CIMARRON HILLS SOUTHEAST MIXED USE FILING NO. 1

A RE-SUBDIVISION PLAT OF SOFTBALL WEST SUBDIVISION NO. 2,
SITUATED IN THE SOUTHWEST QUARTER OF SECTION 8, TOWNSHIP 14 SOUTH, RANGE 65 WEST OF THE 6TH P.M.,
COUNTY OF EL PASO, STATE OF COLORADO

DRAWN BY: DH	PREPARED BY:
			CHECKED BY: JRB	
			SCALE: N/A	
3	05/06/2026	THIRD SUBMITTAL - PRELIMINARY	DATE ISSUED: 08/14/2026	
2	09/08/2025	SECOND SUBMITTAL - PRELIMINARY		
1	08/19/2024	FIRST SUBMITTAL - PRELIMINARY		
#	REVISION DATE	COMMENTS	SHEET 1 OF 3

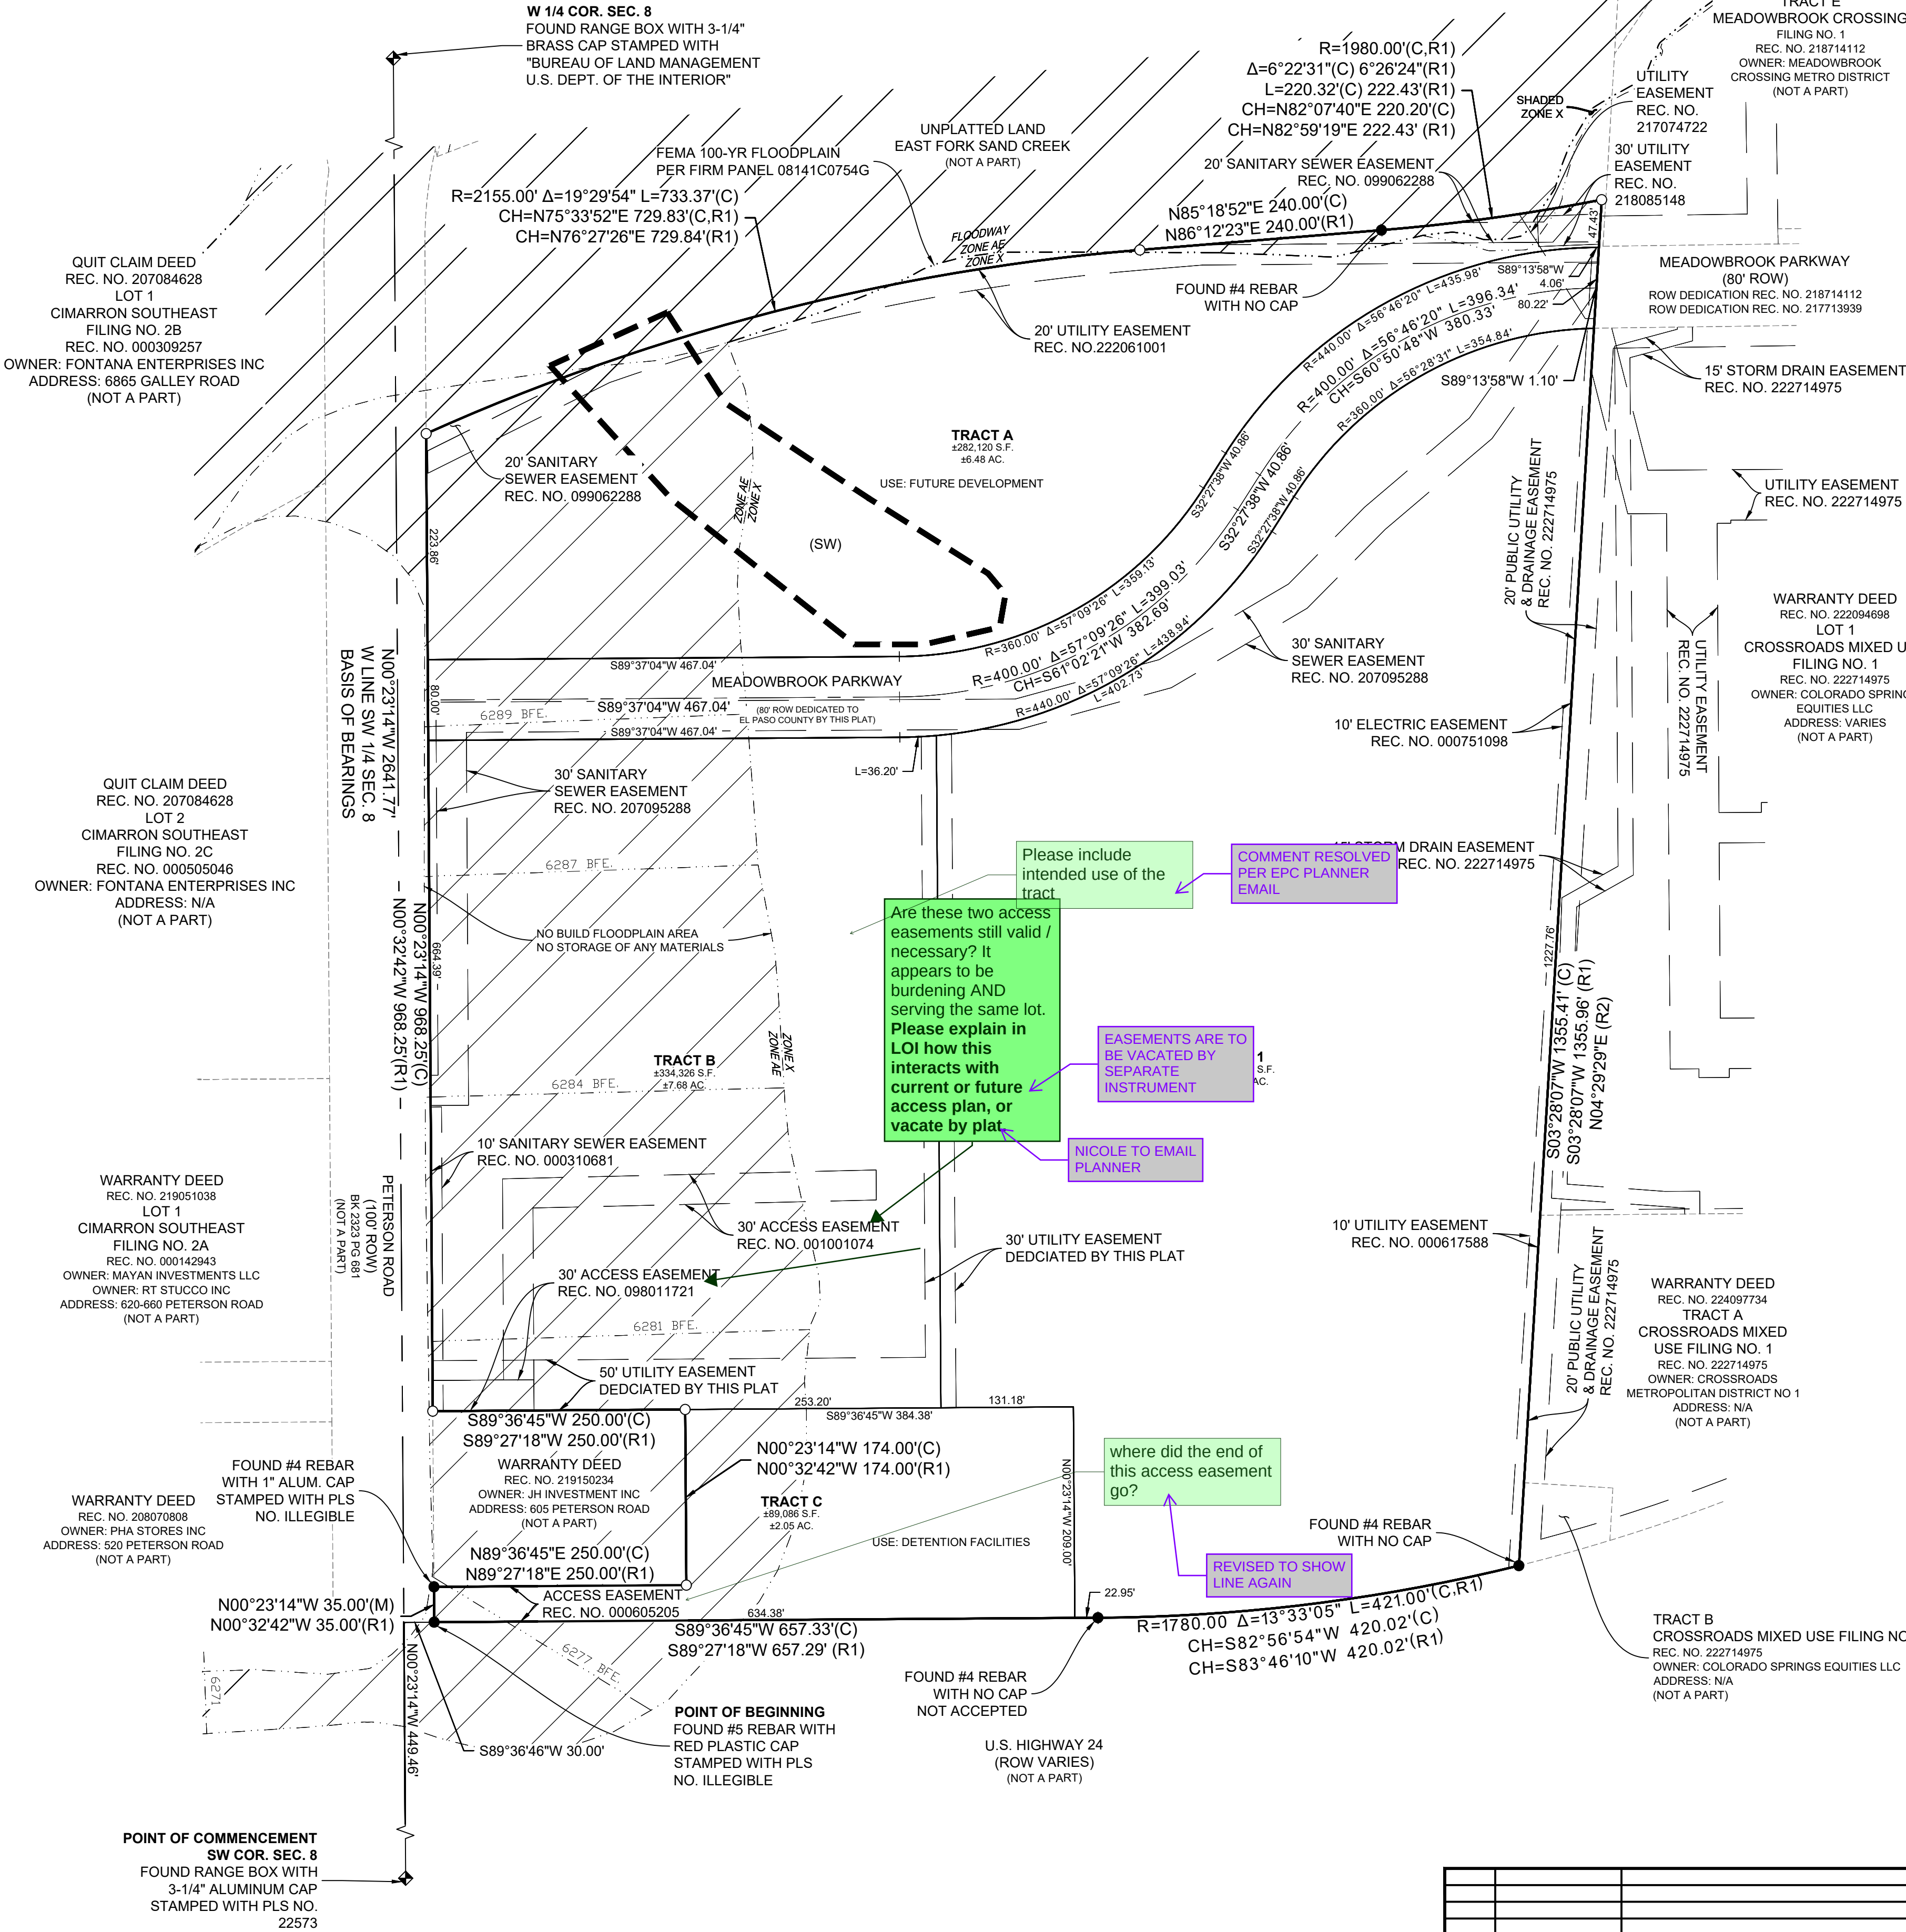
Site Development Plan notes that Tract C will be owned and maintained by HOA. Please include plat note that dictates ownership and maintenance of tracts, with spaces for recorded covenants. Please submit covenants with next submittal.

MAINTENANCE WILL BE HANDLED BY OWNER, IF OWNERSHIP TRANSFERS SO WILL MAINTENANCE ACCORDING TO DMA
